Office Action Summary

10/634,967

COOK ET AL.

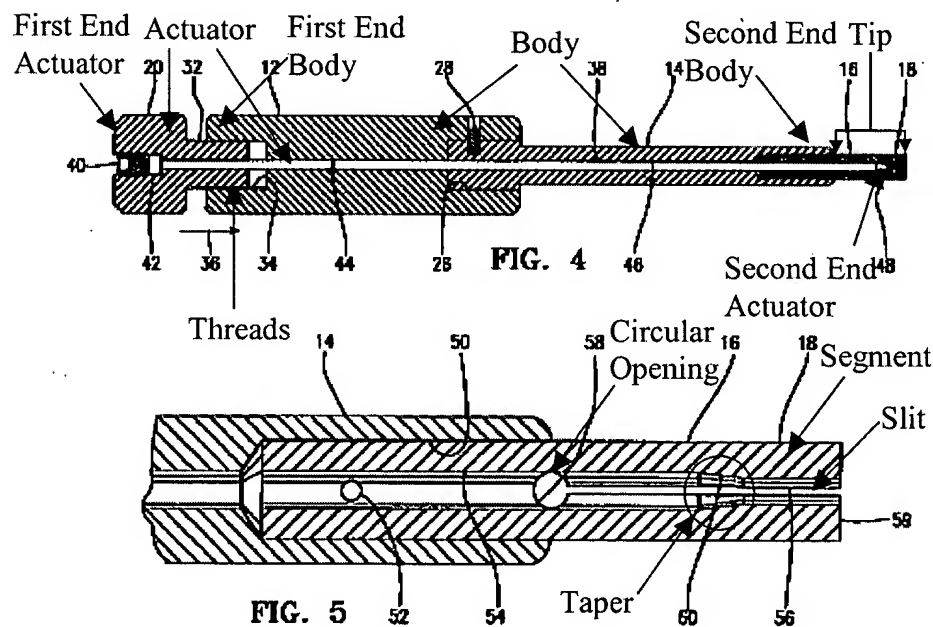
Hajianpour discloses a screwdriver with a holding feature for socket head

screws (reference figures 4 and 5 below). Regarding claim 1, Hajianpour shows an instrument with a body (12, 14, 16, and 34) that includes a first end, a second, and an axis between. Hajianpour also shows an engagement tip (16) adjacent to the second end that is receivable by the work piece. The tip (16) is divided by a slit (56) that form segments with the ability to extend outwardly and grip a screw or nail. Regarding claim 3, Hajianpour shows an instrument that has a body with a bore (44 and 46) that extends from the first end of the instrument towards the tip of the instrument and continues a predetermined distance past the beginning of the slits (56). Hajianpour also teaches an actuator (20, 32, 38, 40, 42, and 48) having a shaft (38) that is placed into the bore (44 and 46) of the instrument body (reference figure 4 below). The actuator can be translated axial through the body of the instrument between an unlocked position, in which the actuator is not biasing the tip segments, and a locked position, in which the actuator is biasing the tip segments. Regarding claim 4, Hajianpour shows an actuator that uses threads (32) to engage threads (34) within the body of the instrument (column 4 lines 29-31). Turning the actuator causes it to turn axially between the locked and unlocked positions (column 4 lines 32-34). Regarding claims 5-7, Hajianpour shows that body contains a bore (44 and 46) that contains a tapered section with a larger first diameter and a second smaller diameter. The taper is located past the beginning of the slit (56) located in the tip (16) of the instrument. When the actuator is engaged with the taper, the segments of the instrument tip (16) are expanded outwardly (column 5 lines 3-7). Regarding claim 8, Hajianpour shows an actuator with a tapered end (48) that bias the segments of the instruments tip (16) when engaged with the taper in the bore (44

and 46) of the body. Regarding claim 9, Hajianpour shows the bore (44 and 46) extends completely through the body of the instrument. Regarding claim 10, Hajianpour shows that the slits (56) that through the tip (16) of the instrument terminate with a circular opening (58) to reduce stress concentrations (column 4 lines 51-54). Figure 5 shows the radius of the circular opening (58) to be greater than half the width of the slit (56).

FIG. 10

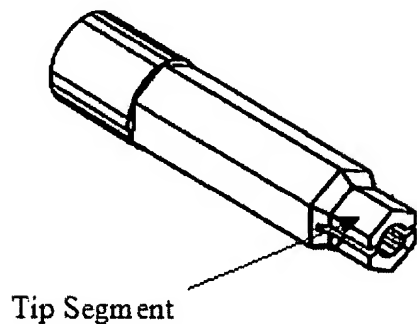
Regarding claim 11, Hajianpour shows an instrument tip (16) that engages a screw or nail in a torque transmitting relationship. Regarding claim 12, Hajianpour shows an instrument tip (16) that has a hexagon shape, reference figure 10 below, which includes flats and vertices to increase the engagement between a screw or nail and the instrument tip (16). Regarding claim 14, Hajianpour disclose that the segments of the instrument tip (16), when biased by the actuator, have at least one vertex that engages the screw or nail. Regarding claim 15 and 16, Hajianpour discloses an instrument that can be used on any screw or pin, including pins or screws used in rotating hinge knee prosthesis, with an internal socket. Regarding claim 20, Hajianpour discloses a device wherein the actuator biases the segments near the segment bases as the actuator is being introduced to the segments. Regarding claim 21, Hajianpour discloses a device wherein the actuator is limited in displacement by the engagement of the second end of the actuator and the first end of the body. With regard the statement of intended use and other functional statements, they do not impose any structural limitations on the claims distinguishable over Hajianpour, which is capable of being used as claimed if one so desires to do so. *In re Casey*, 152 USPQ 235 (CCPA 1967) and *In re Otto*, 136 USPQ 458, 459 (CCPA 1963). Furthermore, the law of anticipation does not require

In response to the applicant's argument that Hajianpour (U.S. 6,286,401) fails to disclose the engagement tip not being slit through the vertices, it is noted in Figure 10 (shown above) Hajianpour discloses an embodiment of the engagement tip wherein the vertices are not intersected by the tip.
